Re: Initial Submission Review: Take 5 Oil Change on Havana - Conditional Use and Site Plan Amendment
Application Number: DA-1458-26
Case Numbers: 1993-6001-06

Initial Submission Review

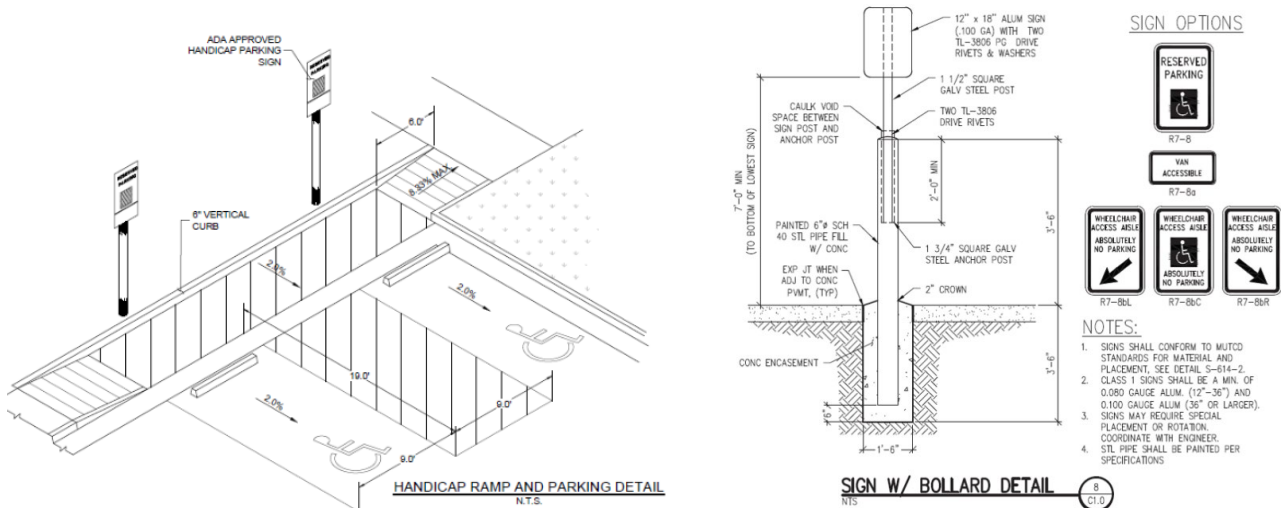
- 11A. See redline: Show or add a note that there will be no vehicle access from Havana Street.
